Date: July 31, 2006  
 Refer to: EP2006-0707

**SUBJECT: RESPONSE TO "APPROVAL WITH MODIFICATIONS FOR THE INVESTIGATION WORK PLAN FOR THE NORTH CANYONS, SEPTEMBER 2001, LOS ALAMOS NATIONAL LABORATORY, EPA ID #NM0890010515"**

Figure 1.4-1. Locations of Bayo, Barrancas, Rendija, and Guaje Canyons

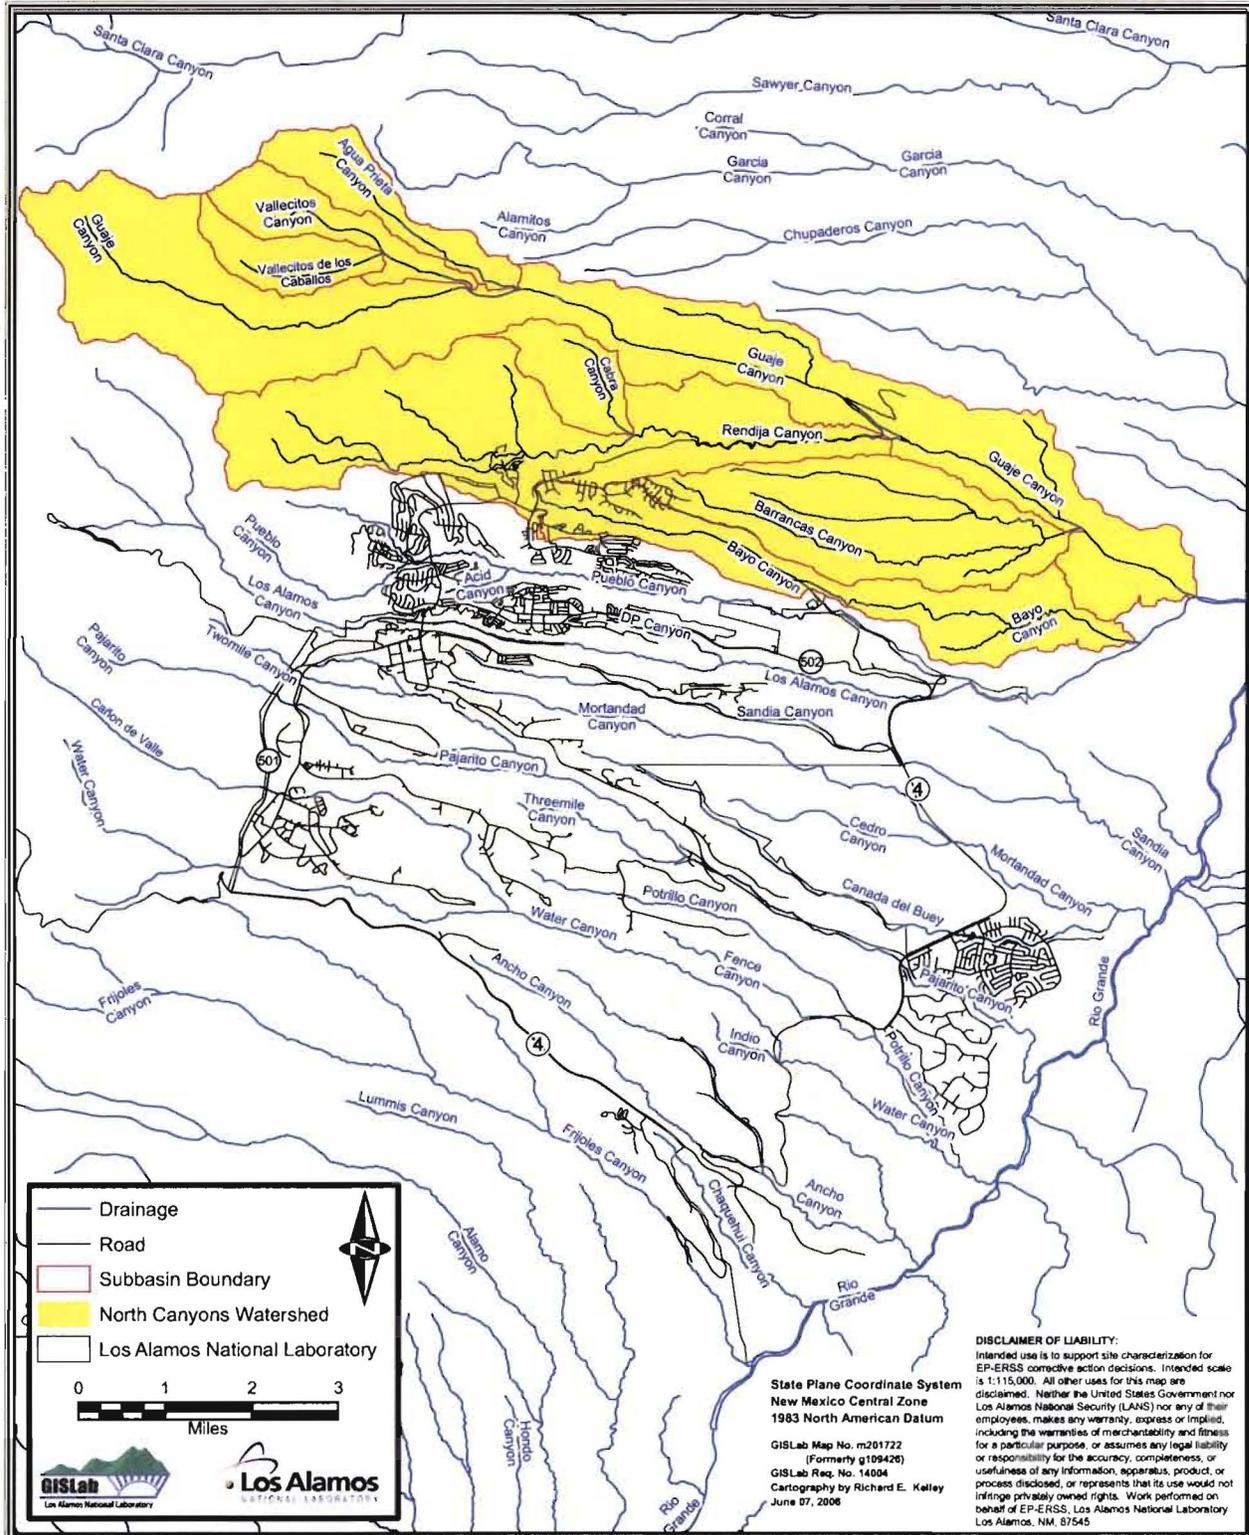
- 1) In response to NMED general comment 1, a table is attached that provides a brief description of standard operating procedures (SOPs) relevant to this investigation.
- 2) In response to NMED general comment 2, Figure A-1 has been modified to add SWMUs 10-003(a-o) and 10-007, and Figure 1.4-1 has been modified to show the correct watershed boundary. These figures are attached.
- 3) In response to NMED specific comment 4, Figure A-1 (attached) has also been modified to reflect the current status of wells.
